Responses-to-Comments Table

Application for Amendment of Plan under Section 12A of the Town Planning Ordinance (Cap. 131) for Proposed Residential Development and Associated Infrastructure at Various Lots in D.D. 32 and Adjoining Government Land, Wong Yi Au, Tai Po, New Territories (Application No. Y/TP/42)

Responses to Comments – Departmental Comments

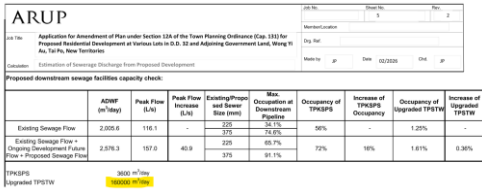
No.	Comments	Responses
	<p>(b) For the western side of the proposed access road, please present the buffer from the proposed road kerb, not the site boundary.</p> <p>(c) Please check carefully whether the buffer distance requirements stipulated in HKPSG could be fulfilled. If the requirements could not be fulfilled, quantitative cumulative impact assessment would be required to evaluate the potential air quality impact to confirm the compliance of the prevailing AQOs criteria.</p> <p>(d) Please remove unnecessary lines to present a clean site boundary.</p> <p>7. Section 6.7: Please state whether any potential odour sources were observed during the site inspection</p> <p>8. Executive Summary and Section 10.1.1.5: Please supplement the conclusions for odour sources and the proposed access road.</p> <p>9. We are aware that many of the previous submission comments have not been addressed. Please ensure that all outstanding comments are addressed in the next submission. Also, please provide the response to comments and highlight the changes in the next submission to facilitate our review.</p> <p><u>Noise</u></p>	 <p>Noted and Figures 6.2-6.3 have been updated in the revised EA (Appendix C) accordingly.</p> <p>As summarised in Table 6.6, the buffer distance requirements stipulated in HKPSG could be fulfilled.</p> <p>Revised accordingly in the revised EA (Appendix C).</p> <p>Based on site observation, there is no odour impact identified to the proposed development. The above has been supplemented in Section 6.7 in the revised EA (Appendix C) accordingly.</p> <p>The conclusions have been supplemented in the relevant sections in the revised EA (Appendix C) accordingly.</p> <p>Noted. All changes in the main text are highlighted in the revised EA (Appendix C) to facilitate your review.</p>

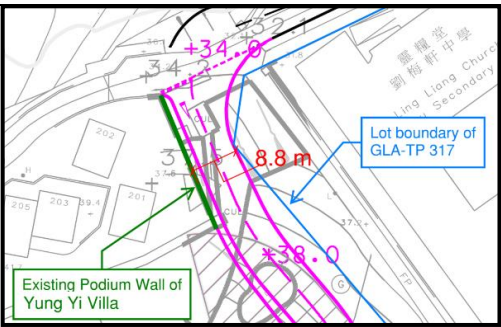
No.	Comments	Responses
	<p>4. In addition, the management and maintenance responsibilities for the proposed roadworks shall be clarified. In particular, the proposed modification to Ha Wong Yi Au Road is not managed by TD, and the new access connecting the site to Ha Wong Yi Au Road solely serves the development, please note that TD will not take up the management and maintenance responsibility. The applicant shall consult relevant departments accordingly. In addition, it is noted that a portion of the access road is included within the boundary of the rezoning application. As this road serves as a vital link for the nearby secondary school, local villages, and existing residential clusters, please clarify whether alternative access will be provided during the construction stage to ensure uninterrupted connectivity.</p>	<p>significant and broadly similar, further optimisation appears constrained and may potentially affect other traffic movements and/or safety provisions.</p> <p>Based on the assessment results, the Applicant has explored practicable physical improvement measures for the junction, including localised widening of the southbound approach of Nam Wan Road, as presented in the TIA report.</p> <p>In view of the above, based on the revised assessment incorporating updated traffic conditions and adjacent development assumptions, while J1 is anticipated to operate under constrained conditions in the design year, the traffic contribution from the Proposed Development would be minimal and is not expected to give rise to any significant traffic impact on the junction.</p> <p>Noted. The Applicants are willing to undertake the management and maintenance of modified Ha Wong Yi Au Road, and the new access connecting the site to Ha Wong Yi Au Road within the Application Site, subject to the discussion with relevant government departments in the later stage.</p> <p>The construction works will be undertaken along the existing road network via Yung Yi Road and Ha Wong Yi Au Road. The proposed road modification works mainly involve localized carriageway widening. On this basis, it is considered that at least one traffic lane could be maintained, and full road closure is not anticipated during the construction works. It is intended that vehicular and pedestrian access to the nearby secondary school, local villages, and existing residential clusters will be maintained at all times throughout the construction period.</p> <p>In the event that temporary partial road closures are required to facilitate the construction works, appropriate Temporary Traffic Arrangement (“TTA”) will be implemented in accordance with the latest edition of “Code of Practice for the Lighting, Signing and Guarding of Road Works” published by the Highways Department.</p>
